**CERTIFICATE OF APPROPRIATENESS**

**Property:** 1810 State Street, Lot 6, Block 441, Baker W R NSBB Subdivision. The property includes a historic 1,060 square foot, one-story wood frame single-family residence and a noncontributing 336 square foot one-story wood frame accessory structure at the rear of the lot situated on a 5,000 square foot (50' x 100') interior lot.

**Proposal:** Alteration – Replace all wood 105 siding with cementitious lap siding and make the following alteration on the south (street) elevation:

**PHOTOS OF SOUTH (STREET) ELEVATION**

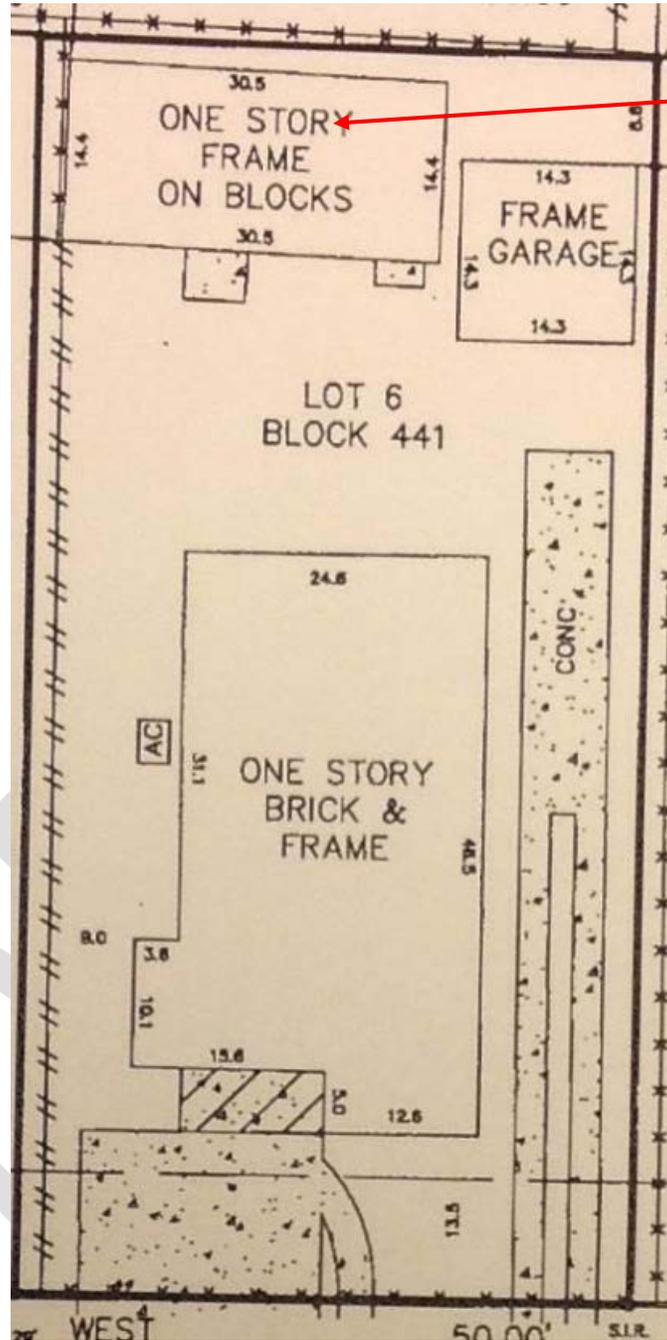
- Replace one wood window with a vinyl window
- Replace one missing window in an existing opening with a vinyl window
- Replace one wood door with a fiberglass window
- Partially patch one unused door opening with siding
- Add one vinyl horizontal window in the upper portion of the unused door opening

REPLACEMENT SIDING AND WINDOWS STREET (SOUTH) ELEVATION

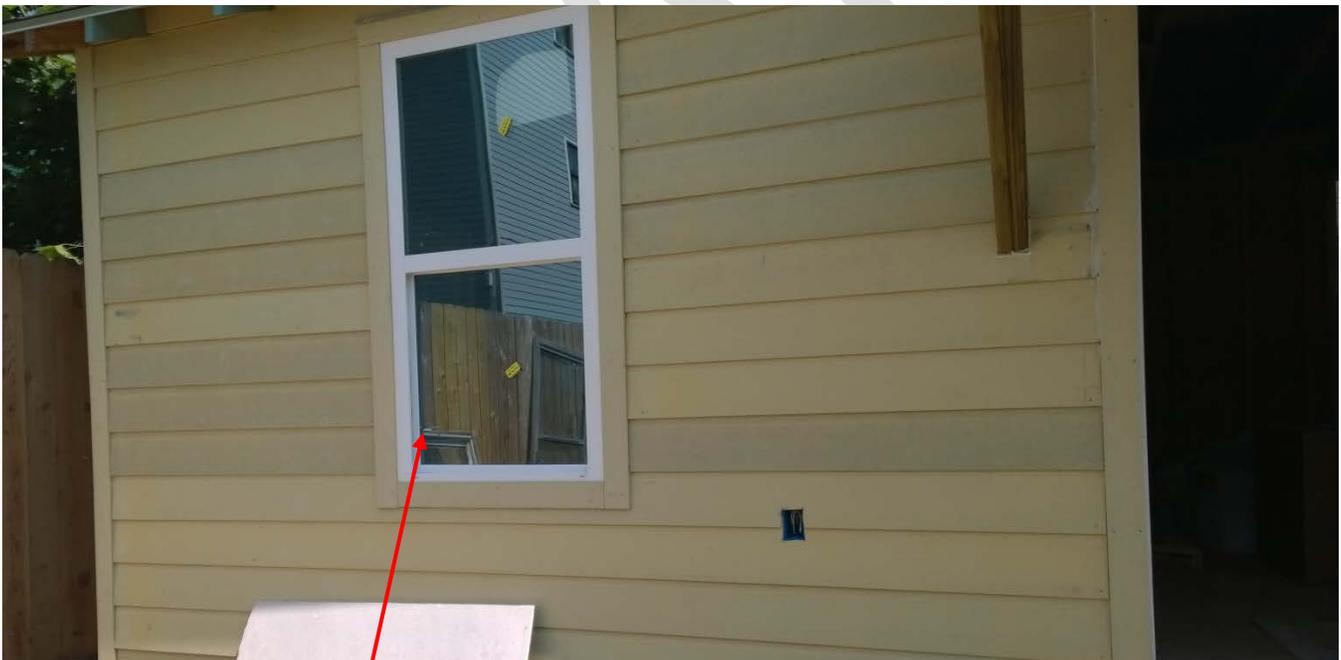
The Old Sixth Ward Design Guidelines explicitly state that "windows shall be vertically proportioned." In the Guidelines, "shall indicates a mandatory provision." One of the three new windows proposed for the structure is horizontally proportioned and violates this "shall" provision. However, though portions of the structure are visible from the right of way, the eastern portion of the elevation containing the horizontal window is completely blocked from view by the contributing residence. Because this residence is contributing, it is unlikely to be removed and the horizontal window will not be visible from the right of way.

*NEW HORIZONTAL WINDOW*
